ADDENDUM NO. 4

PROJECT NAME: UNL Devaney Sports Center Improvements
UNL PROJECT NUMBER: C100P098

DATE OF ISSUANCE: Wednesday, April 11, 2012

<p>Attachment to:</p> <p>Date: 04/12/12</p>	<h1>A101.</h1>
<p>Project Name: DEVANEY SPORTS CENTER IMPROVEMENTS</p> <p>Project Number: 11005</p>	<p>SINCLAIR hille architects</p>

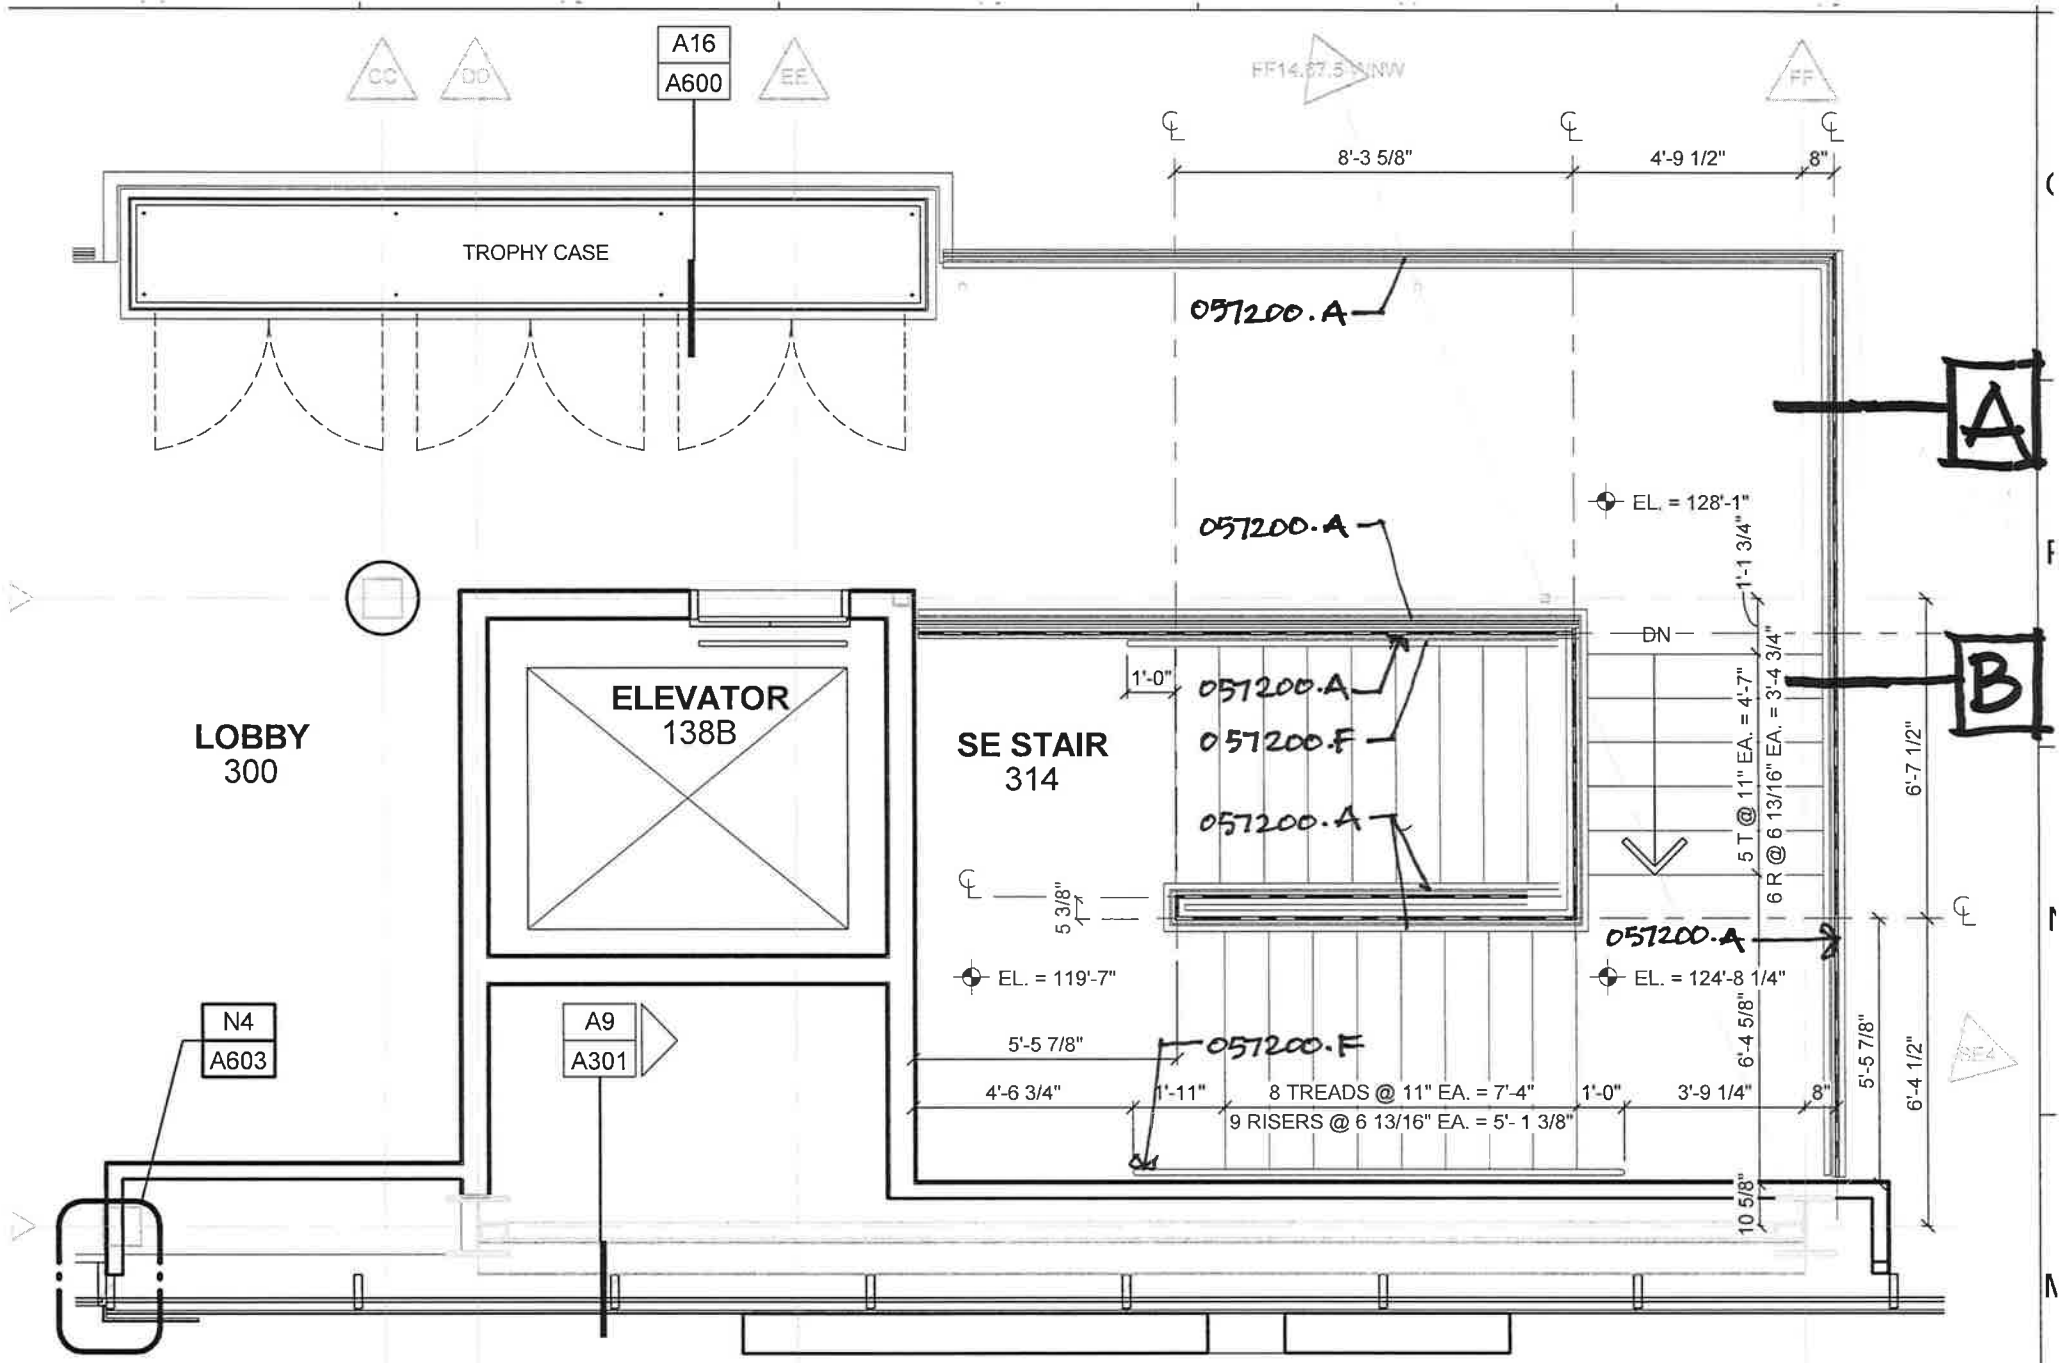
1. DEVANEY CENTER INSPECTION—Due to requests, the Devaney Center will be open for inspection by bidders on Monday April 16, 2012 from 1:00 PM to 4:00 PM. This will be for viewing purposes. No questions can be answered.
2. EXISTING CONCOURSE FLOOR LOAD—A question was asked regarding the load capacity of the existing south concourse floor slab. See Sheet S001-Note G1 that indicates the design live loads as listed on the original construction drawings.
3. ALTERNATE #1 ADD—This alternate is to provide modified restroom and concessions space on the west side of the concourse. The layout of the alternate is a mirror of the restroom and concession on the east side of the concourse. For CLARIFICATION we have attached a plan generally indicating the layout and room numbers for this alternate. Note that Club 280A shown on this alternate plan is to be bid as part of the Base Bid. (See Attachment)

SE STAIR 214

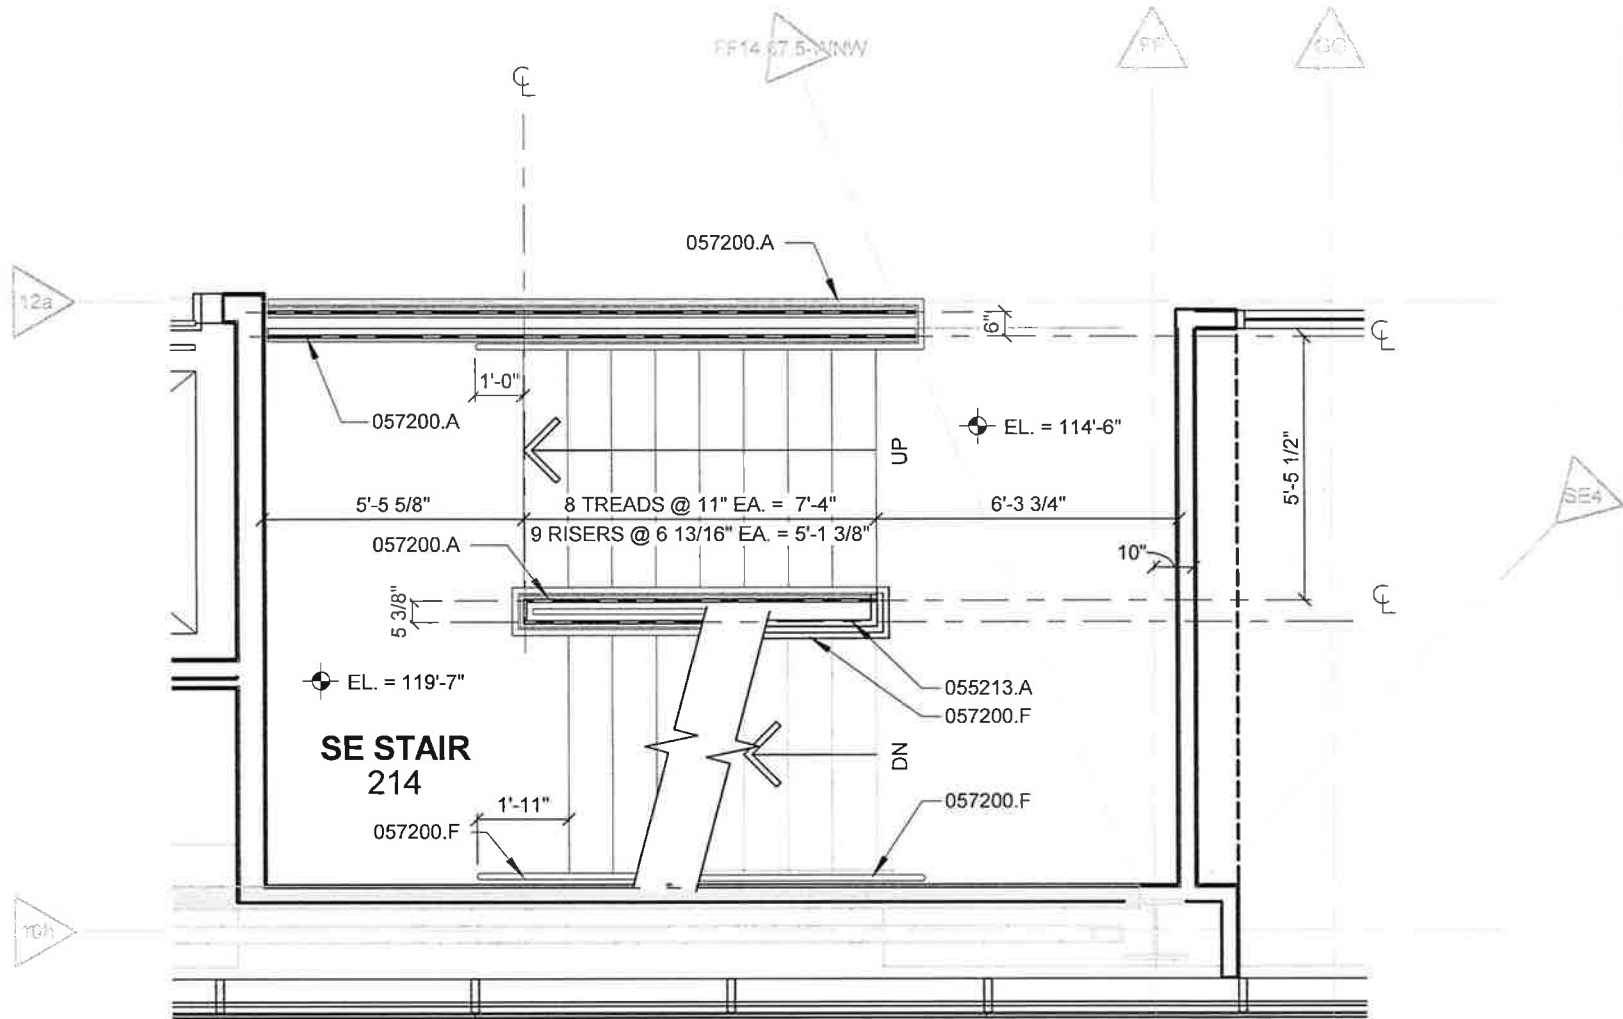
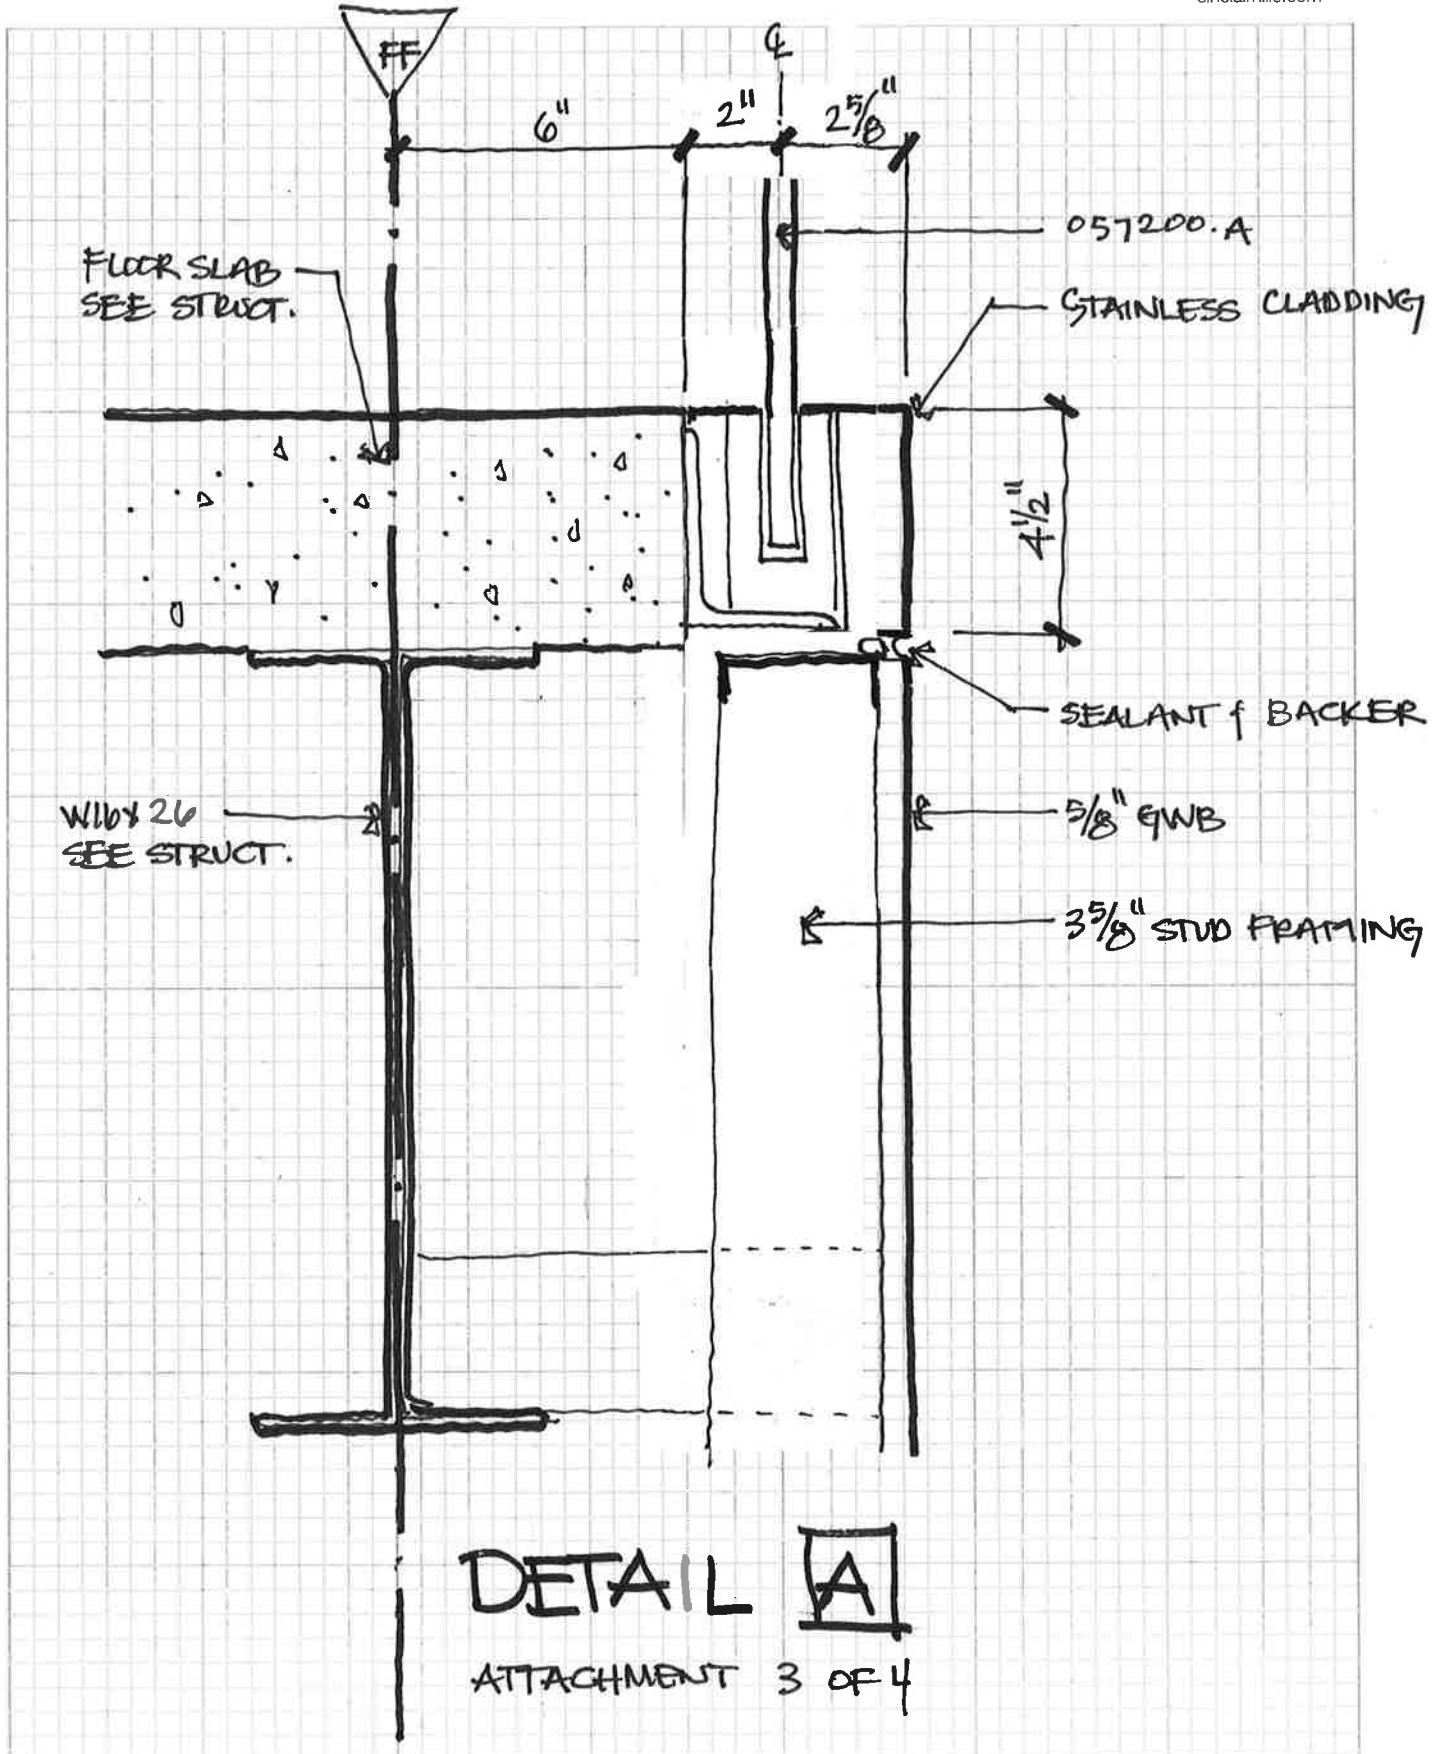
1. At Concessions 282A—replace the (4) existing coiling counter doors with new manual operated aluminum counter doors as specified in Section 083313. The doors are 10'-0" wide x 4'-0" high. (Field Verify actual opening size.)
2. See the attached set of detail sketches for the SE stair—including an enlarged plan at the concourse floor level. (See Attachment)

1. See the attached set of detail sketches for the SE stair—including an enlarged plan at the club floor level. (See Attachment)

UPPER SEATING STORAGE

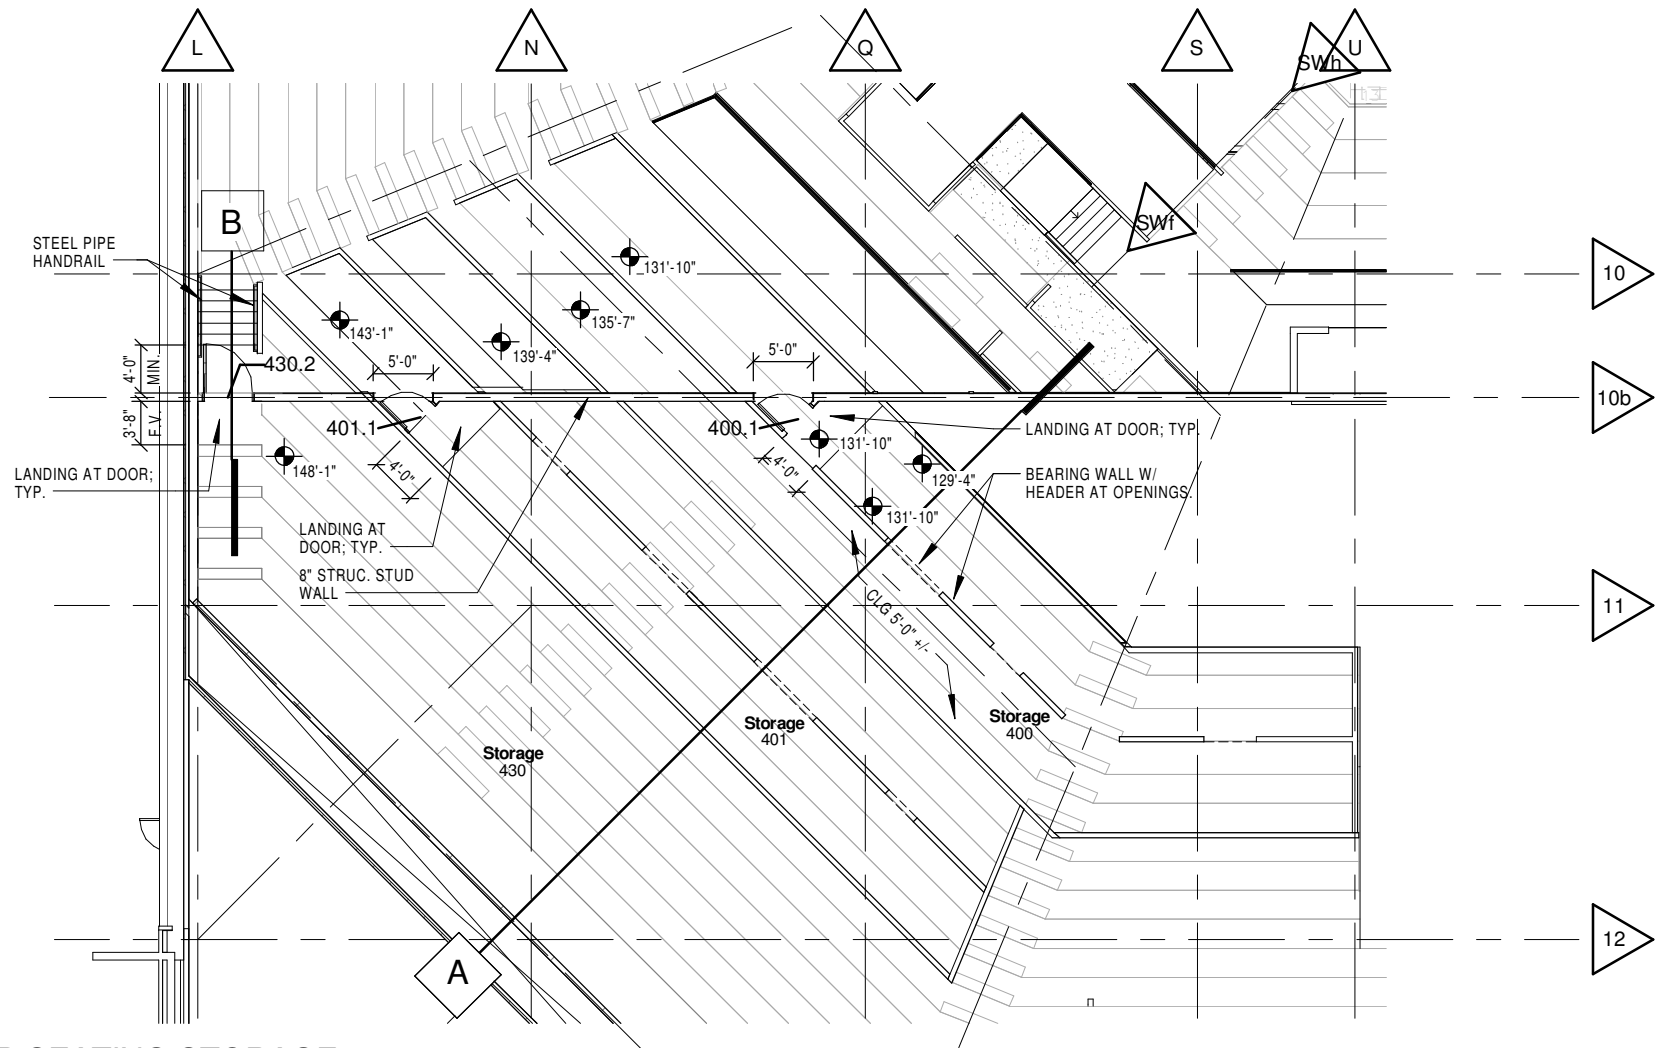
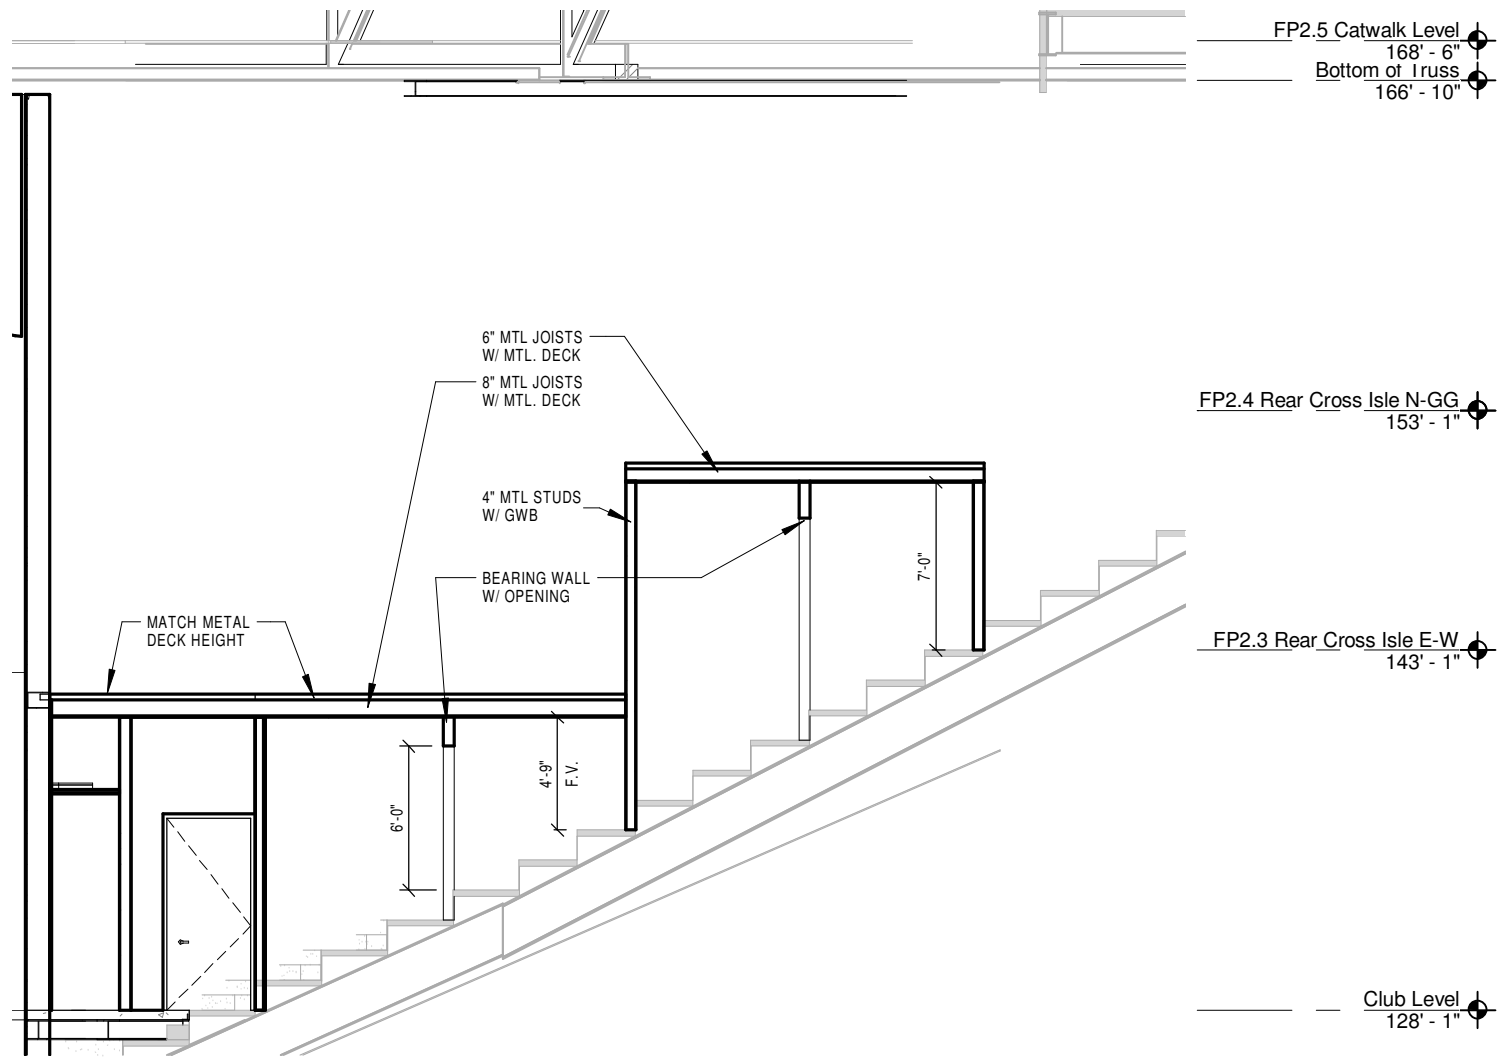
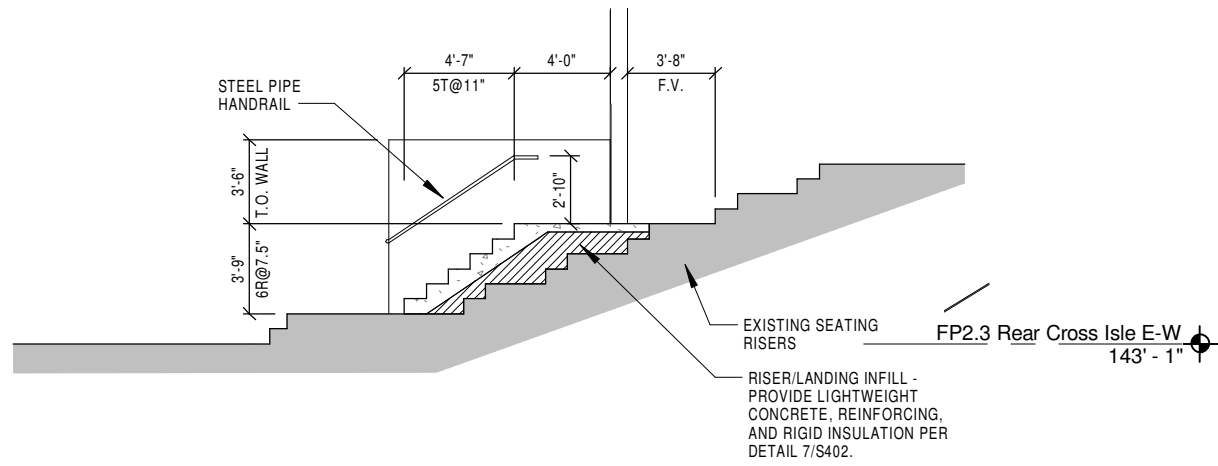
1. Refer to C11-Seating Level Plan. Add 2 enclosed storage rooms in the seat riser area behind the 'great wall'. (See the Attachment) See Mechanical / Electrical Addendum for the M/E work at these new rooms.
The Storage Room work also includes another row of riser overbuild as per Detail 13/S401 with a wall and counter per Detail A1/A602.
The work also includes a stair and landing at Door 430.2 constructed as similar to Detail 7/S402. This landing and stair is also to be constructed at the east side of the 'great wall' at Door 430.1
